PUBLIC UTILITY COMMISSION OF OREGON
STAFF REPORT
SPECIAL PUBLIC MEETING DATE: May 7, 2020

SUBJECT: PACIFIC POWER
(Docket No. LC 70)
Staff Final Report on PacifiCorp's 2019 Integrated Resource Plan.

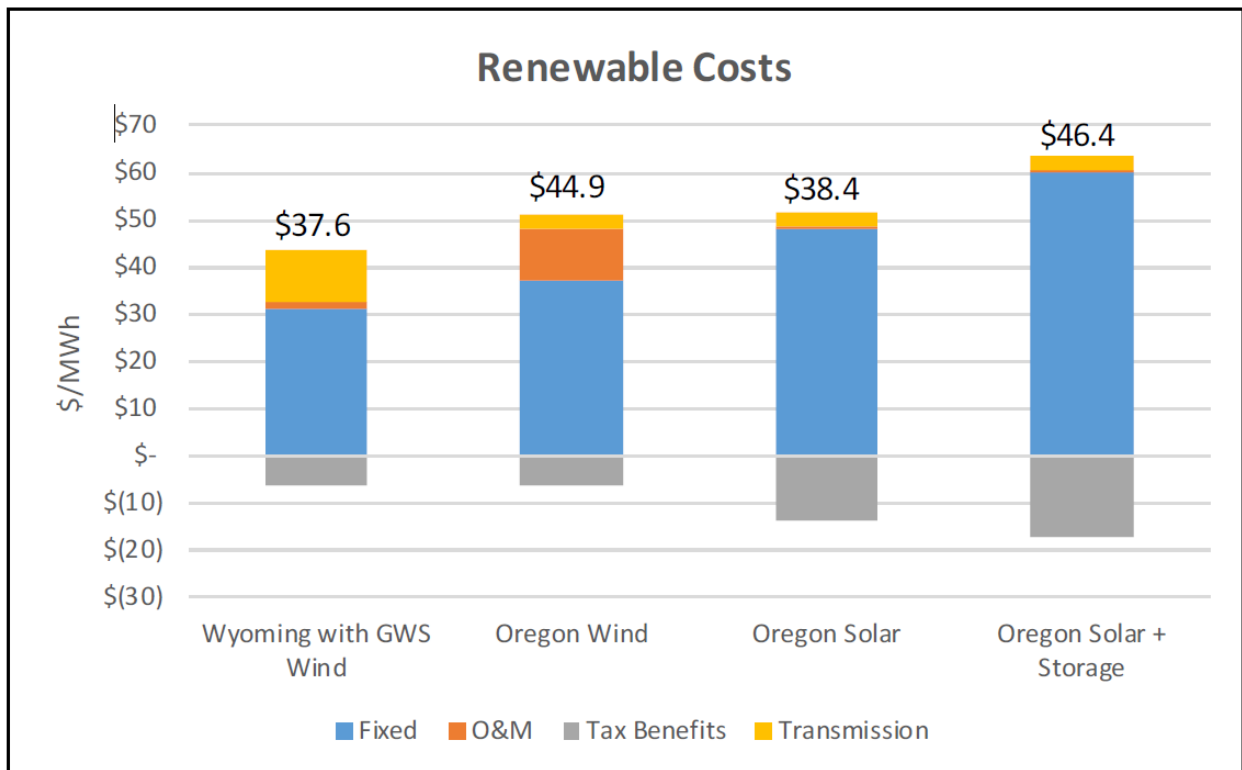
Especially helpful was the chart on page 38 of PacifiCorp’s final comments that provides a per MWh breakout of the comparative costs of EGS plus WY wind versus other projects considered in the IRP. This chart provides the type of information that Staff hoped to see in order to help explain why PacifiCorp’s model chooses EGS.

The chart demonstrates that reduced capacity costs on a per MWh basis and reduced O&M costs are responsible for the relative cost-effectiveness of EGS with WY wind.

Staff has questions about why the O&M costs of Oregon wind are apparently many times that of WY wind or OR solar, and requests the Company be prepared to explain the reasons at the 2019 IRP acknowledgement decision meeting.
